# Pentium<sup>®</sup> Processor for Embedded Applications

Specification Update

*July 1998*

Order Number: 273183-001

**68. Asserting TRST# Pin or Issuing JTAG Instructions Does not Exit TAP Hi-Z State**

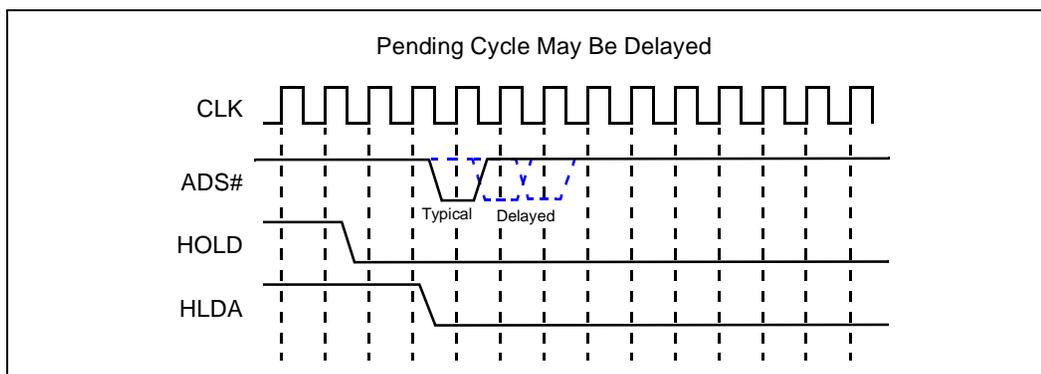
**Problem:** The *Pentium® Processor Family Developer's Manual*, Section 11.3.2.1 states that the TAP Hi-Z state can be terminated by resetting the TAP with the TRST# pin, by issuing another TAP instruction, or by entering the Test\_Logic\_Reset state. However, the indication that the processor has entered the TAP Hi-Z state is maintained until the next RESET. Therefore by using the above methods alone, the TAP Hi-Z state can not be terminated.

**Implication:** When the TAP Hi-Z instruction is enabled and executed, the processor may not terminate the Hi-Z state.

**Workaround:** To exit TAP Hi-Z state, in addition to the methods described above, the processor needs to be RESET as well.

**69. ADS# May be Delayed After HLDA Deassertion**

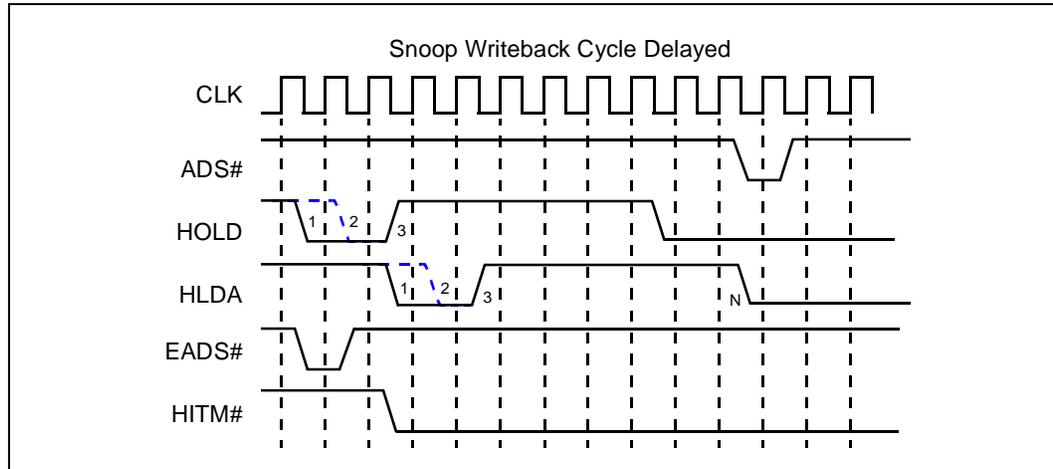
**Problem:** The Pentium processor typically starts a pending bus cycle on the same clock that HLDA is deasserted and the Pentium processor with MMX technology typically starts the cycle one clock after HLDA is deasserted. However, in both processors it may be delayed by as many as two clocks. See the diagram below:

In two cases, for example, if HOLD is deasserted for one clock (i.e., clock 2) or two clocks (i.e., clocks 1 & 2) and then reasserted, the window may not be large enough to start a pending snoop writeback cycle. The writeback cycle may be delayed until the HLDA is deasserted again (i.e., clock N). See diagram below.

**Implication:** If the system expects a cycle, for example a writeback cycle, and depends on this cycle to commence within the HLDA deassertion window, then the system may not complete the handshake and cause a hang.

1. Deassert HOLD for at least 3 clocks (i.e., clocks 1, 2, and 3 shown in figure) before reasserting HOLD again. This ensures that the Pentium processor initiates any pending cycles before reasserting HLDA.
2. If the system is waiting for the snoop writeback cycle to commence, for instance if HITM# is asserted, the system should wait for the ADS# before reasserting HOLD.

## 2. Incorrect TCP Pinout Drawing

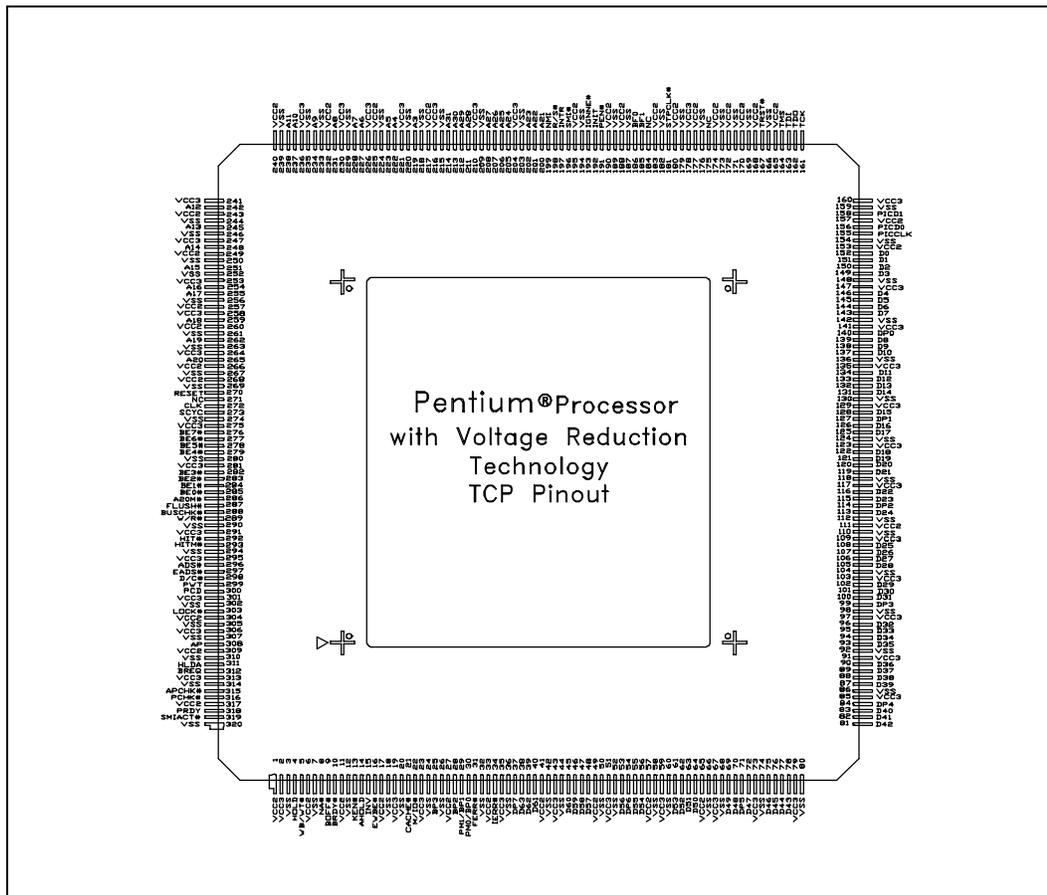
The TCP pinout drawing on page 8 of the *Pentium Processor with Voltage Reduction Technology* datasheet was inadvertently rotated. The correct orientation is shown below.
